PROJECT  
 Old Orion Court  
 Development

SHEET  
 Tree Preservation Plan

04/24/24 SPA
07/15/24 SPA
11/06/24 REVISED PER CITY
01/13/25 SPA REV #2

**SHEET**  
 Landscape Plan

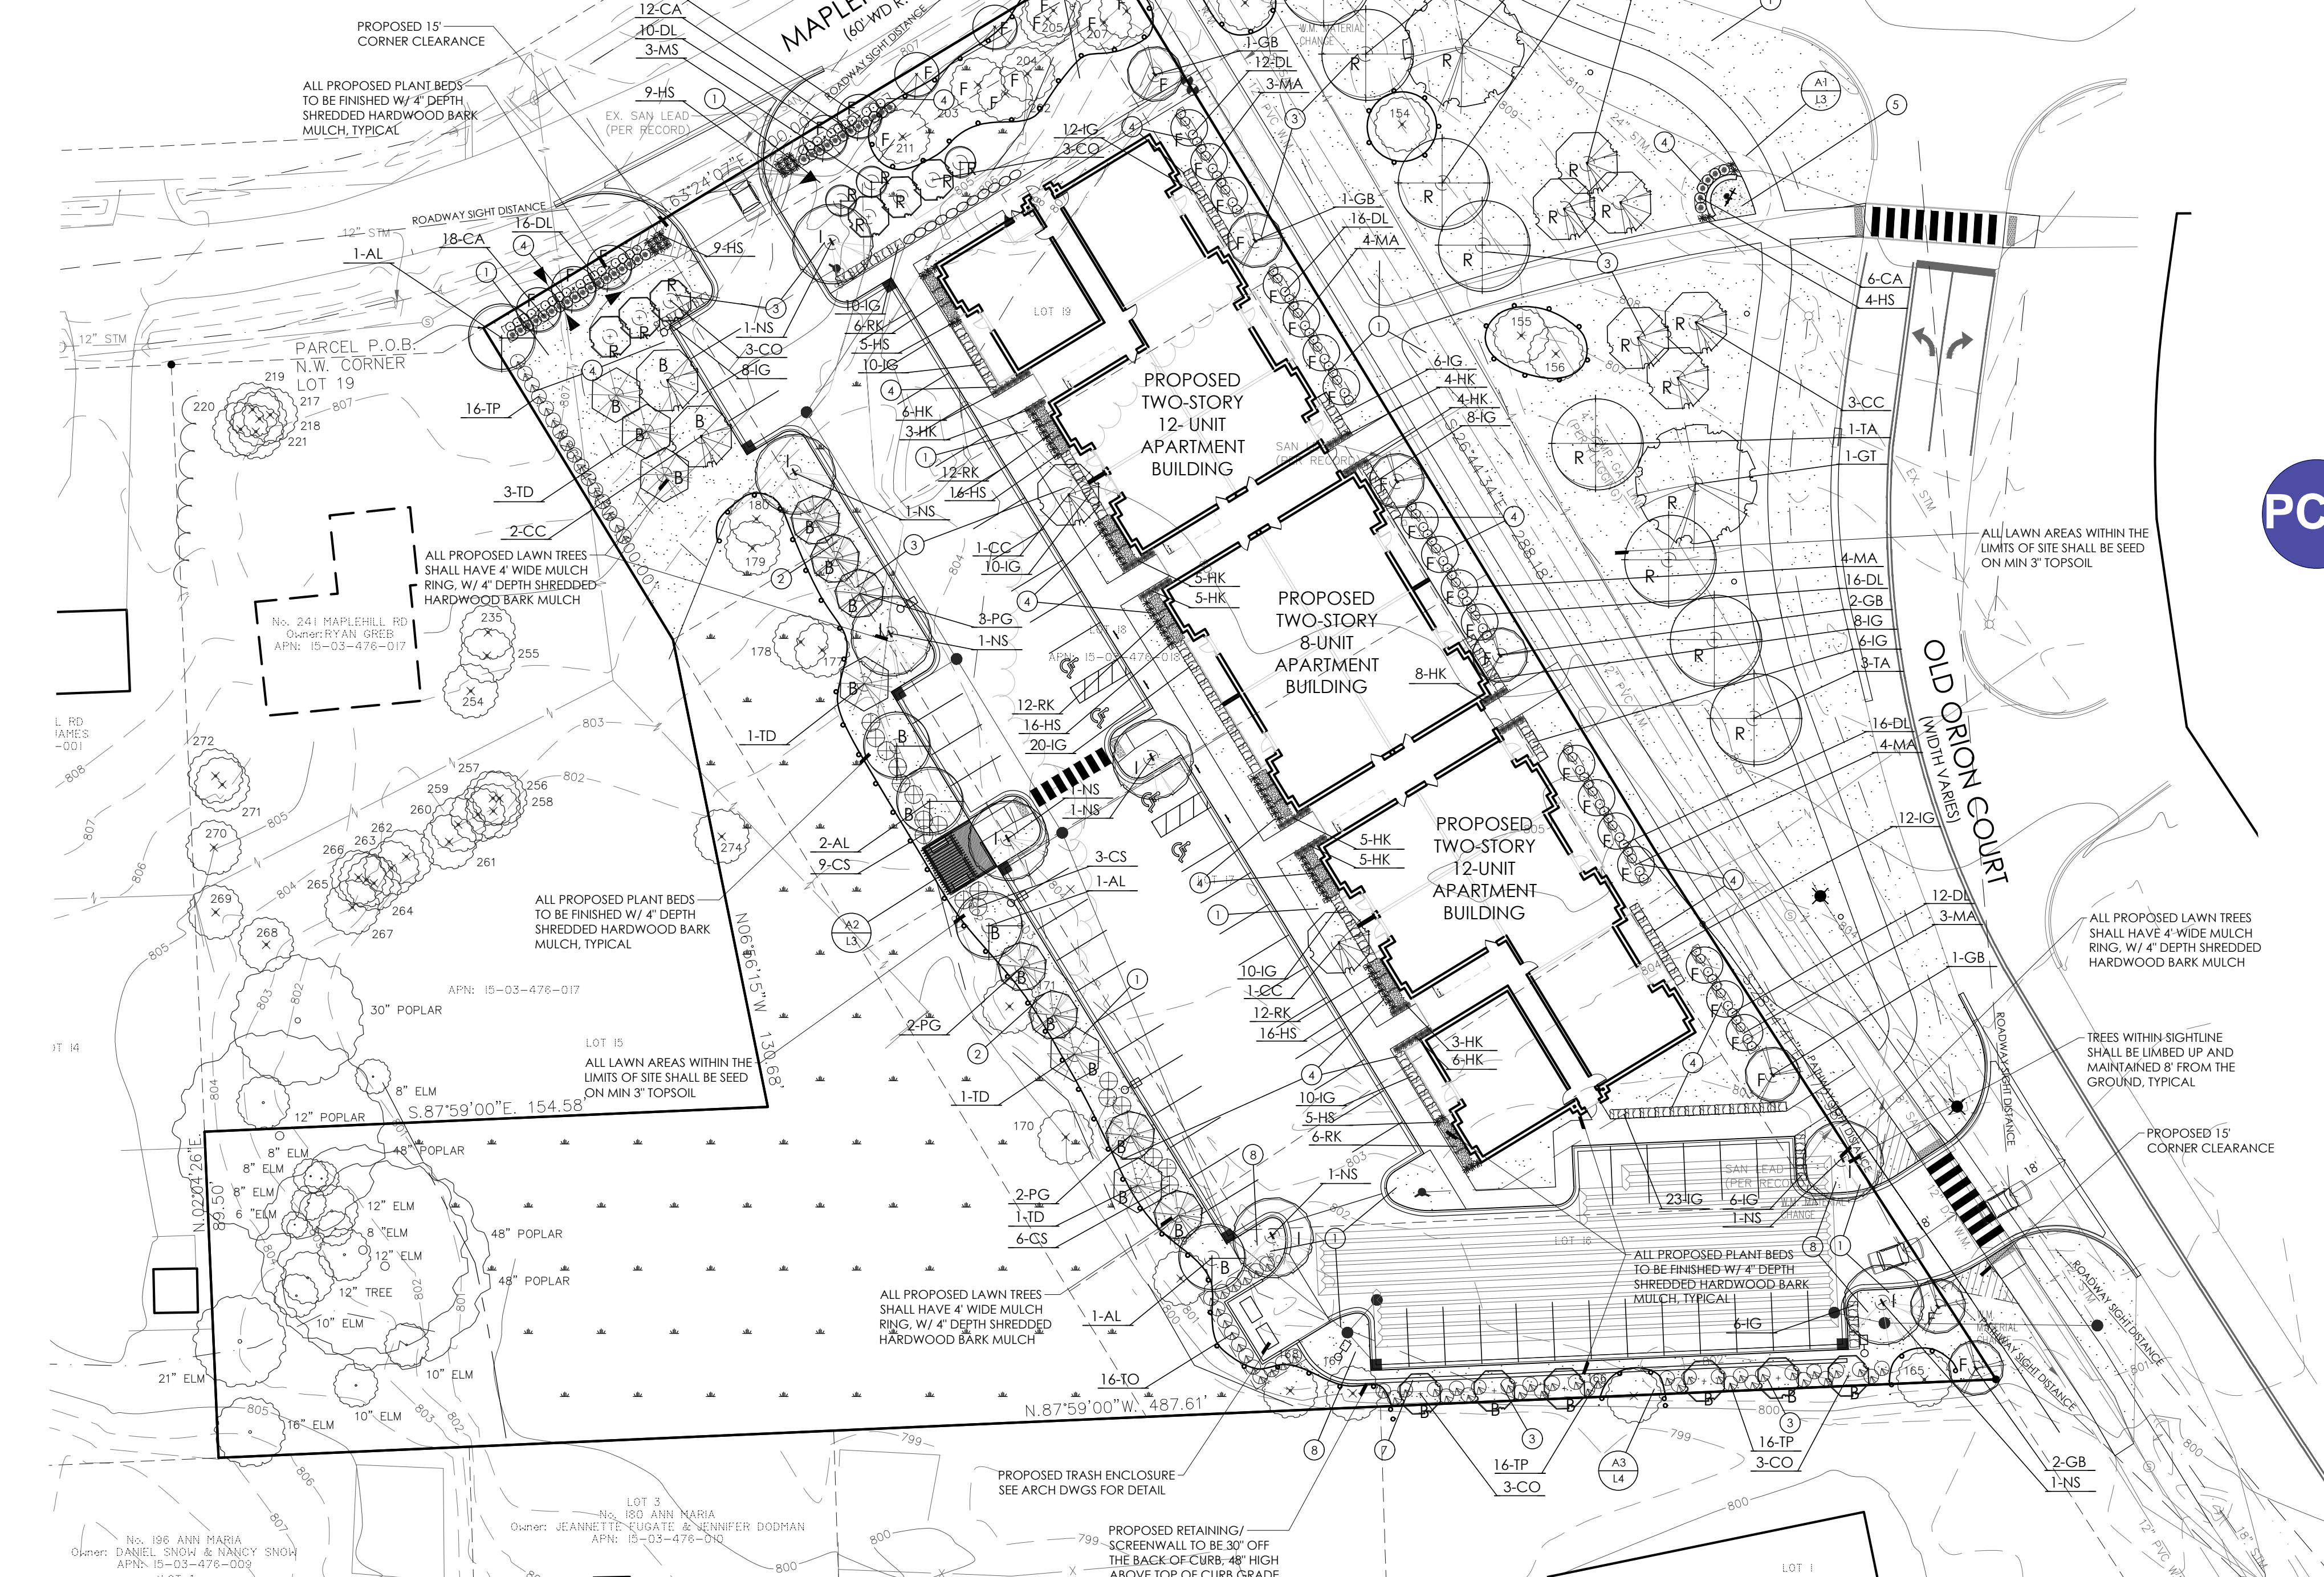
to clarify - new trees should be generally maintained (water/mulch) in this location by developer. However, long term trimming will be completed by City to address public safety, etc. being that they are on the ROW.
